5.2.2 Design Changes

As previously noted by the department, the key modifications to the C3 building relate to establishment of a new northern lobby, changes to the north-western podium, a new north/south through-site link, structural and material changes to the façade (podium & tower) and awnings.

Figure 8: Proposed BMUs (in yellow)

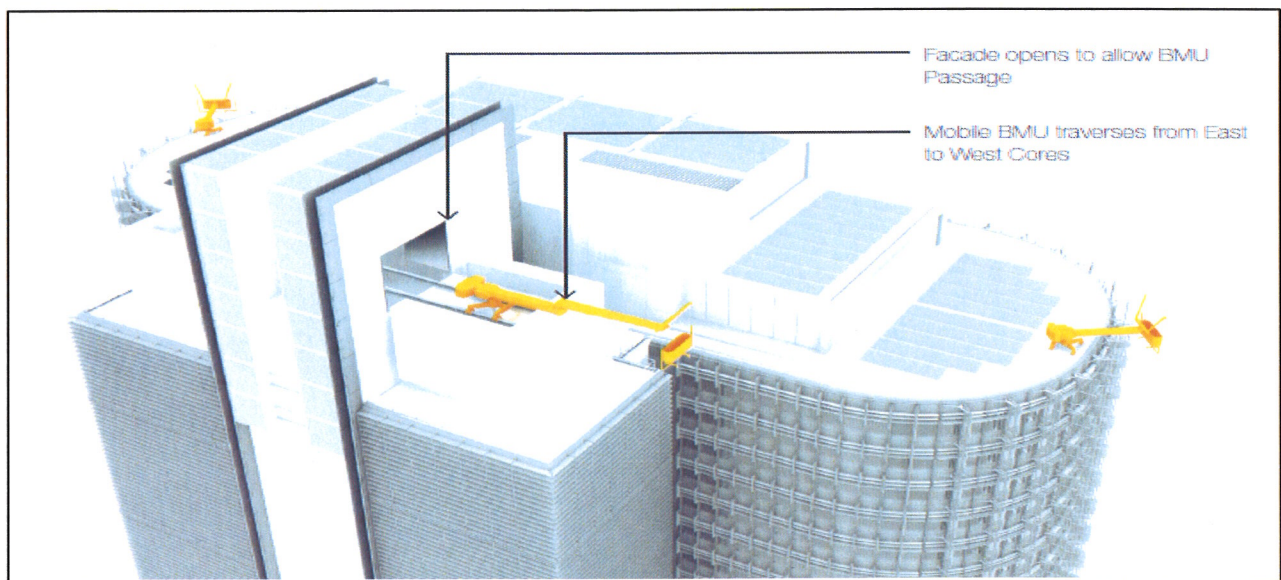
Building management units (BMUs) are used for the cleaning and maintenance of buildings. The BMUs will be erected on the rooftop of the building and above the plant equipment and have a maximum height of 5m (**Figure 8**). As the maximum height of the building under the MD SEPP and Concept Plan is RL 209m the BMUs exceed the maximum height control by 4m (i.e. RL 213m).

The proponent has stated that compliance with the maximum height control is unnecessary as the BMUs will not result in any adverse environmental impacts, will perform a critical function, and are used throughout the Sydney CBD.

- they represent an insignificant mechanical element and addition to the building as they are significantly smaller in size than the building's prominent architectural roof feature (which is exempt from the maximum height definition) and would not be visually obtrusive or discernable at ground level;
- they do not increase the bulk and scale of the building;
- they would not result in any environmental impacts, including overshadowing, wind or view loss impacts;
- they have a critical functional and practical purpose and therefore are in the public interest;
- they are broadly consistent with the MD SEPP's objectives for the site; and
- the contravention of the maximum height limit raises no matters of significance for State or regional planning, and council and the Government Architect have not raised concerns about their installation.

For the reasons outlined above, the department considers that the built form impacts on the building remain sufficiently neutral and considers that the non-compliance with the maximum height limit is justified and reasonable. It is therefore recommended that the Executive Director, as delegate of the Secretary, issue a statement of concurrence to this effect (**Appendix 4**).

Figure 9: Approved rooftop (left) and proposed rooftop (right)

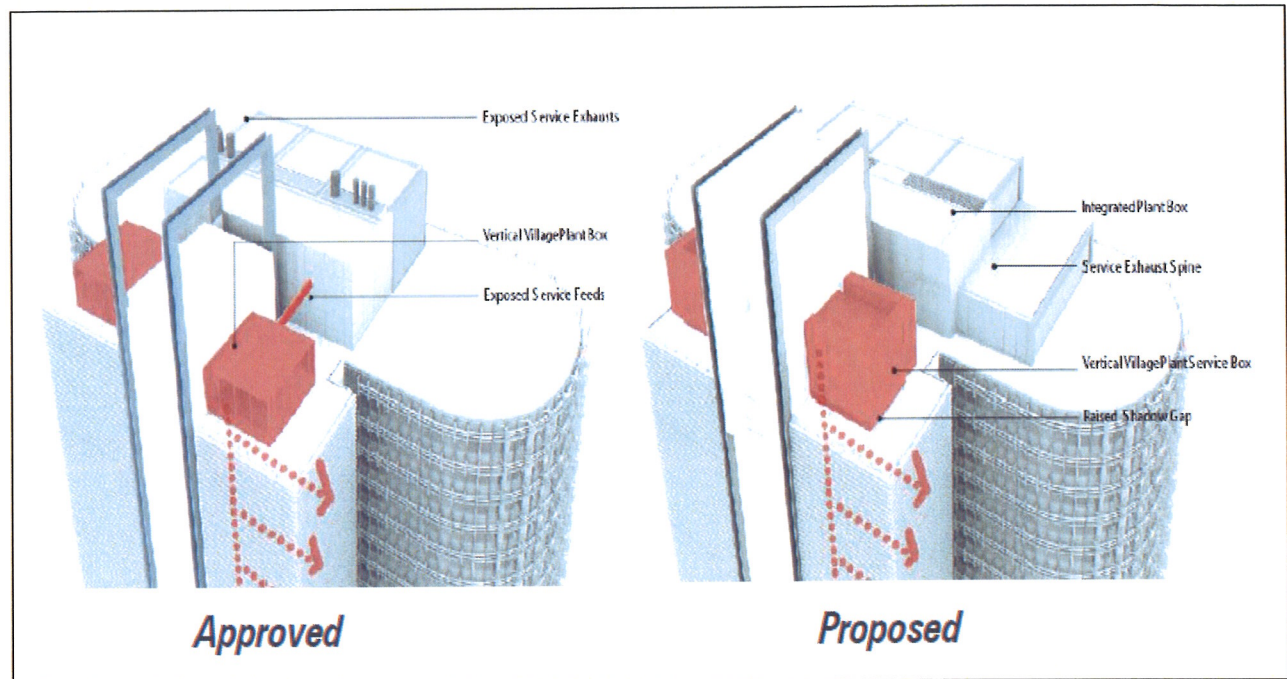
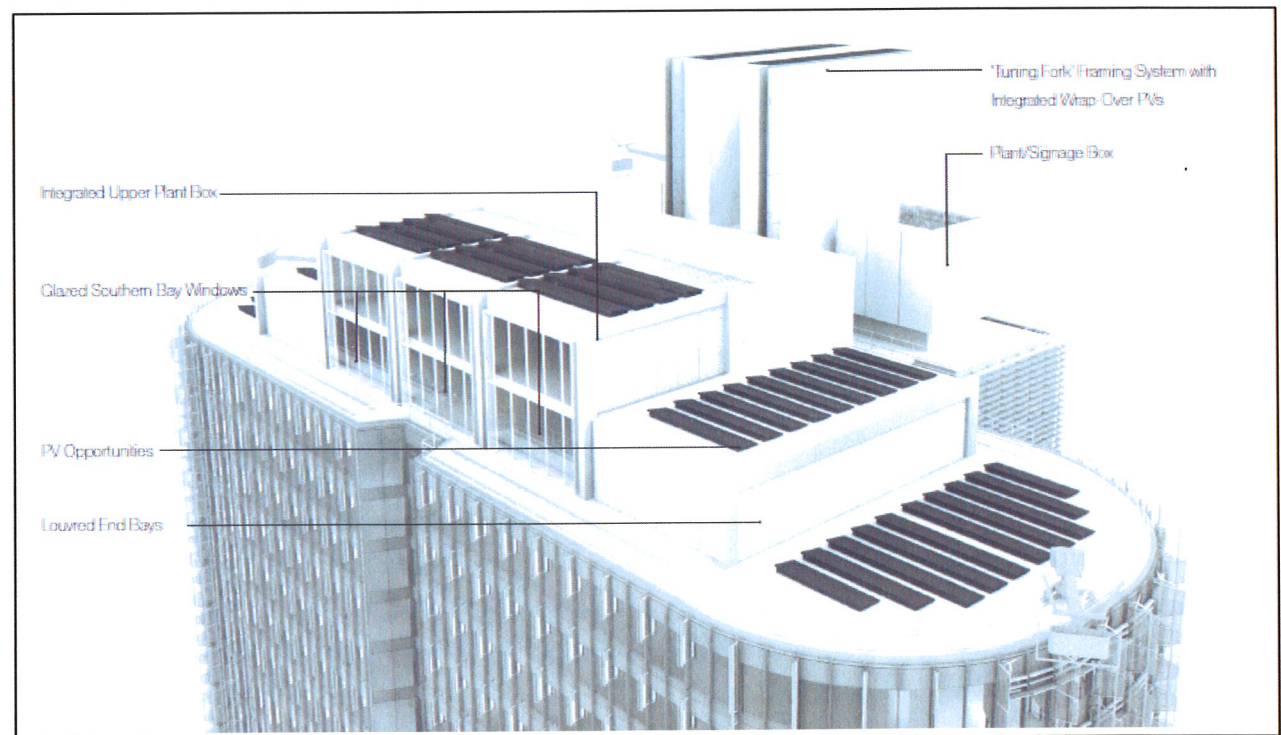
The proposed modifications to the plant rooms reduce the maximum height of the plant rooms by 1m (from RL 209m to RL 208m). The modifications comprise a reconfiguration of the central two-storey plant room (RL 208 m) and two new single-storey wings each at a height of RL 202.6m (**Figures 8-10**). The vertical village plant boxes have also increased in height (just below RL 208 m). The architectural roof feature has been modified so it now is enclosed by PVC cladding but its height remains unchanged at RL 220m.

The department accepts that the additional plant rooms and semi-enclosure of the architectural roof feature slightly increases the overall bulk and massing of the upper part of the building. However, the plant rooms remain within the maximum height permissible and represent a bulk and scale less than what could be constructed if the upper most part of the building was constructed to the same floorplate as the office space below (which is permitted). Further, whilst the architectural roof feature has been modified by PV cladding, it remains open within its central spine.

The department therefore considers that the modifications to the rooftop only moderately increase the bulk and scale of the rooftop and are reasonable and acceptable.

Figure 11: Approved setback (left) and proposed setback (right)

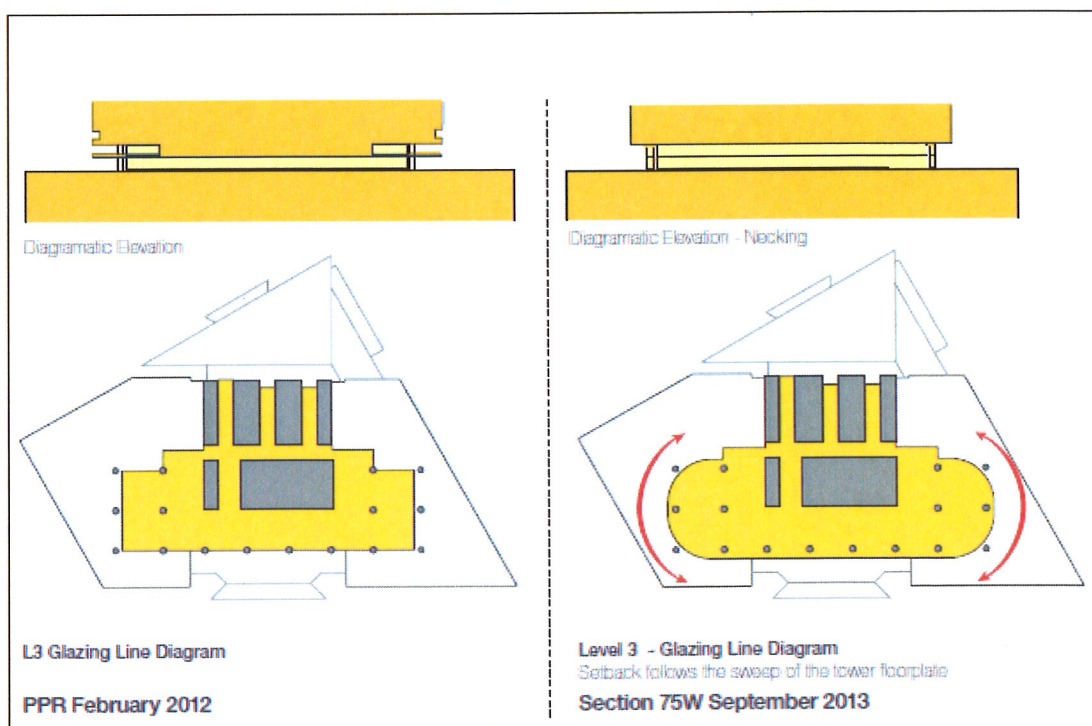
The proposed key changes to the tower's façade includes a full double-floor setback between the podium and tower (part double previously) which follows the tower floorplate; refinement of the colour scheme; solar shading elements, structural bracing alterations, and the articulation of the glazed lift shafts (**Figures 7 & 11**).

The department is supportive of the changes as they are moderate in scope, are more akin to design refinements, and do not change the fundamental design of the building. The new double-storey setback between the podium and tower, in particular, significantly improves the separation between the two building elements and enhances the setback of the tower above the podium. On this basis, the design changes to the tower are considered to be acceptable and supported.

Figure 13: Proposed link through C3's podium

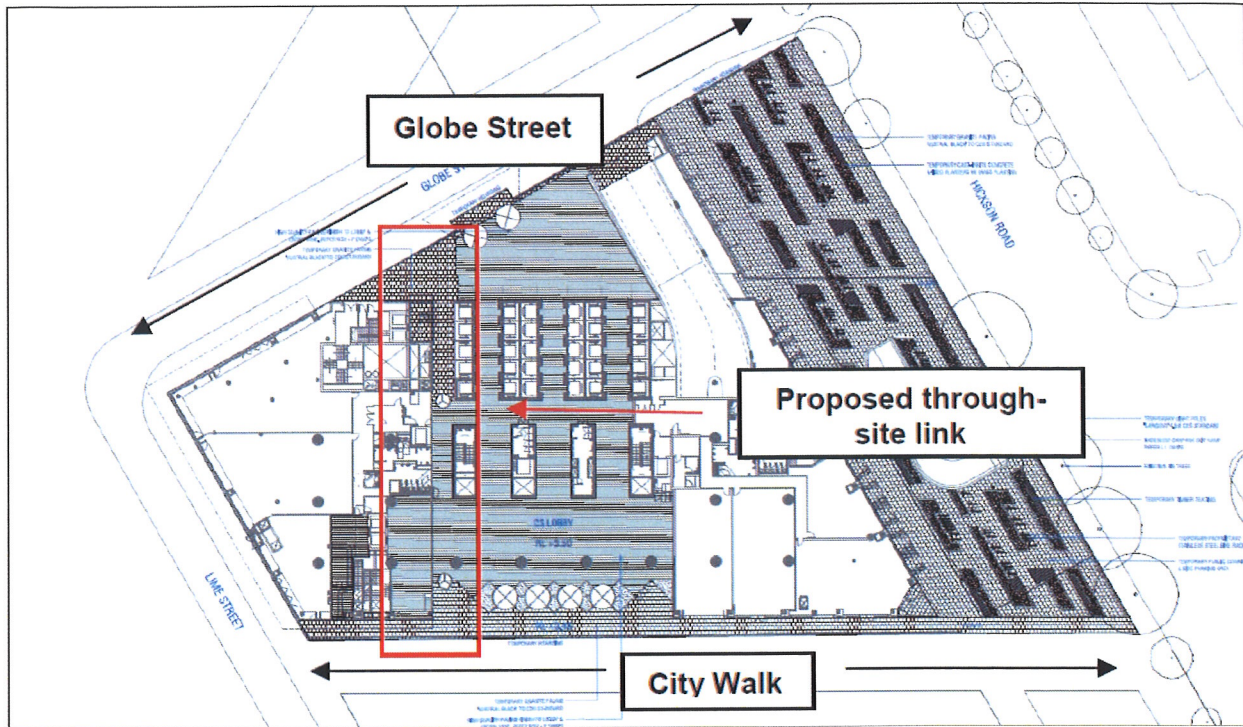
The Government Architect supported the principal of the through-site link but raised concerns regarding the legibility of the link's entry (wayfinding signage & articulation of the facade) and that shelter is not provided at both entry points.

The department has given careful consideration to the photomontage (**Figure 12**) and plan (**Figure 13**) provided in support of the application, and in keeping with the principle of good urban design, considers that the entry to the through-site link is not immediately recognisable or obvious, and needs to be more legible as recommended by the Government Architect.

Although the proponent has stated this will be achieved through different material selection, footpath treatments and tiling (internal), Condition A10 (2) will still require the proponent to lodge revised plans to illustrate the legibility of the through-site link.
